Final Environmental Impact Report

THE MEALY STREET FREIGHT RAIL DIVERSION

The Long Beach-Los Angeles Rail Transit Project

November 1987

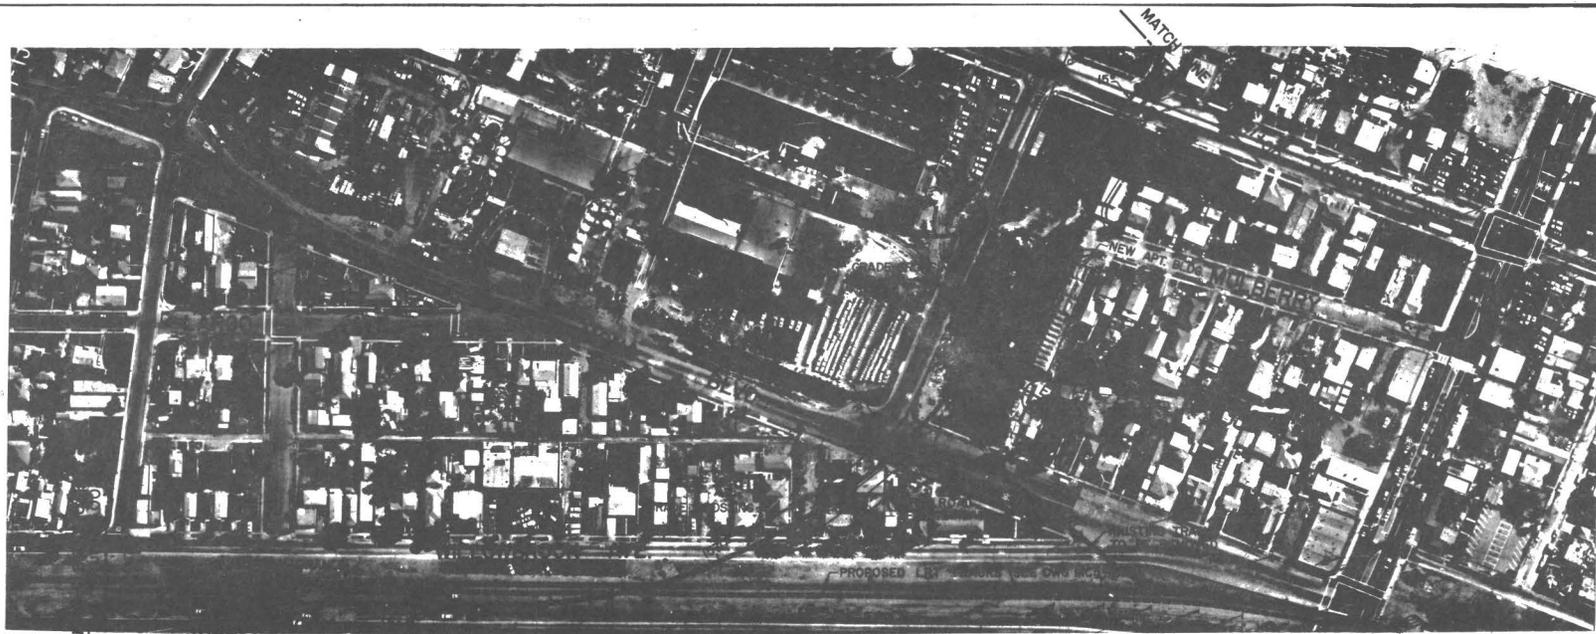
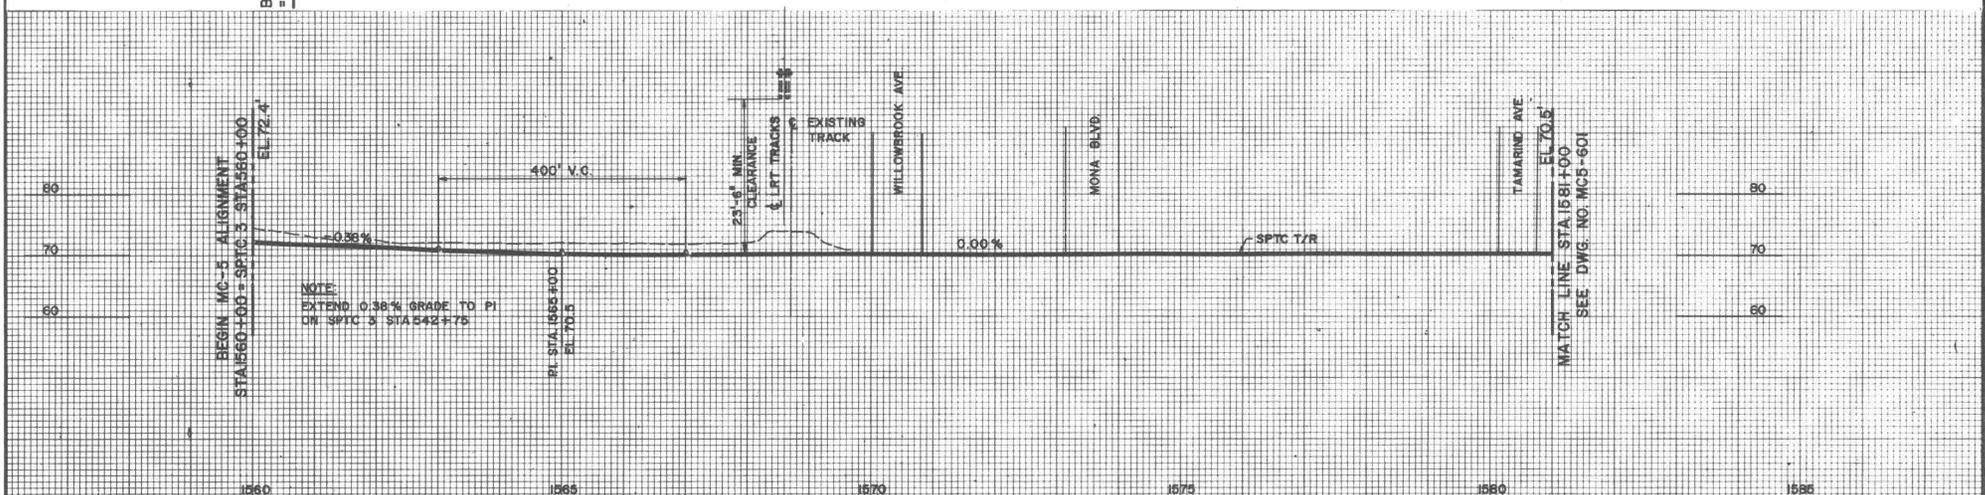
Section I-322 of the DEIR described the techniques to be used in the construction of SPTC tracks. Since the proposed relocation of the team track would be entirely within the existing the San Pedro Branch ROW, it is not anticipated that there would be any significant adverse impacts to the surrounding area beyond those discussed in the DEIR. That document did point out a potential for noise and dust impacts during construction. Any construction sequencing would have to maintain railroad operations. The SPTC does not see any serious problems with such maintenance during the proposed construction for the relocated team track.

NOTE:
GRADE CROSSINGS ARE NOT TO BE PROVIDED ACROSS SPTC TRACKS AT MONA BLVD. AND TAMARIND AVE.

Revised Figure III-31A

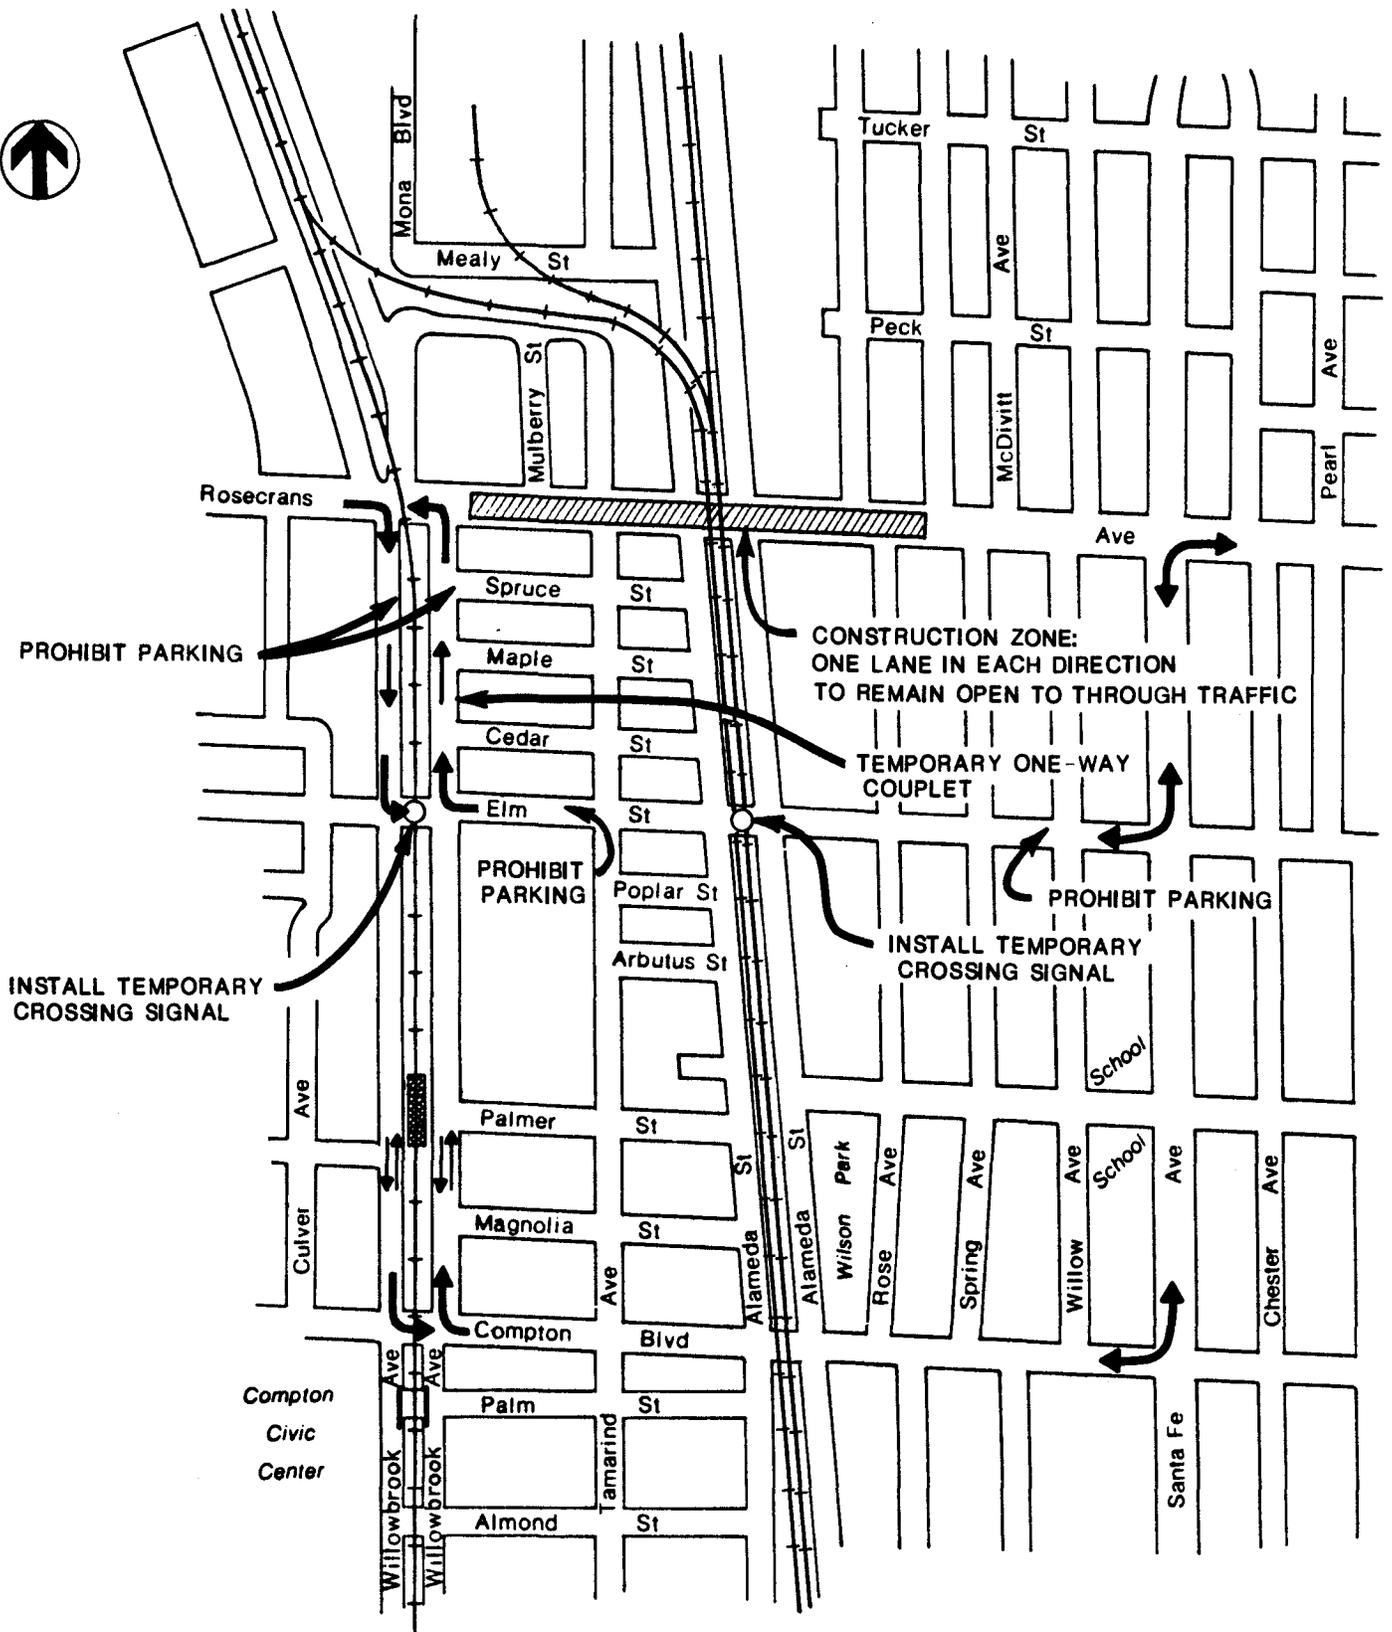
A decision was made to relocate the Compton Station of the Long Beach-Los Angeles Rail Transit Project from Compton Boulevard north to Palmer Street. The relocation of the Compton Station to Palmer Street would preclude the use of Palmer as a temporary detour route because Palmer could no longer be extended across the Wilmington Line. The LACTC and the City of Compton have agreed that the existing crossings of the Wilmington Branch at Palm, Laurel and Indigo Streets would be permanently closed as part of the project, and that a number of street improvements for mitigation of traffic impacts will be made.

As a result, a new detour route south of Rosecrans has been identified in consultation with City of Compton staff. This route entails the utilization of Willowbrook Avenue, Elm Street and Santa Fe Avenue, as illustrated in Revised Figure III-31A.

In order to effectively implement the new detour plan, a number of traffic engineering improvements are recommended to accommodate the increased traffic volumes along Willowbrook, Elm, and Santa Fe without significant congestion delays to the detoured traffic.
